REFERENCE:	TSB: 08-121-23 GROUP 08 - Electrical	Date:	May 6, 2023	REVISION:	—
VEHICLES AFFECTED:	2022 (DT) RAM 1500 Pickup This bulletin applies to vehicles equipped with the following: Global Telematics Box Module (Sales Code RDG).			MARKET APPLICABILITY: <input checked="" type="checkbox"/> NA <input type="checkbox"/> MEA <input type="checkbox"/> SA <input type="checkbox"/> IAP <input type="checkbox"/> EE <input type="checkbox"/> CH	
CUSTOMER SYMPTOM:	Customers may experience one or more of the following: <ul style="list-style-type: none"> • Uconnect Box Message at Startup. • Uconnect Box Error Or Requires Service Message. • Connectivity: Uconnect Mobile App trunk status showing as closed when trunk is open. • Connectivity: Diagnostic Trouble Codes (DTCs) for Electronic Control Modules (ECUs) won't be shown to customer through the Vehicle Health alert (Mobile app or email). 				
CAUSE:	TBM Software

Fig. 1
Uconnect Box Error Message

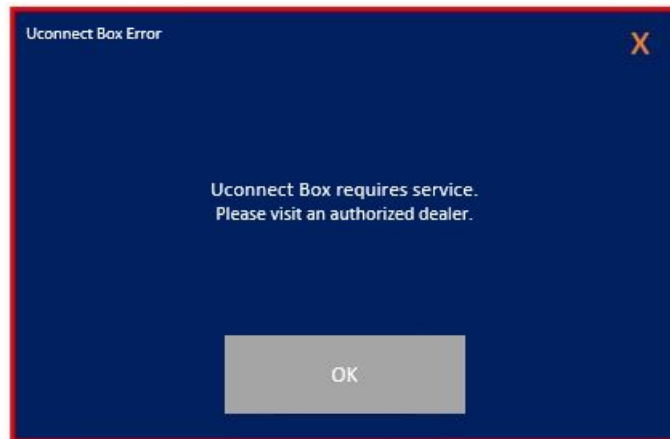
Message display on the radio screen, “Uconnect Box requires service. Please visit an authorized dealer.” (Fig. 1) , with no active or stored DTCs set by the TBM.

This bulletin provides information regarding the latest Firmware Over The Air (FOTA) update and provides the service technician an overview of the steps a customer will need to take to complete the update. The TBM software will be updated from 4.13 and 5.25 to 5.39.1.
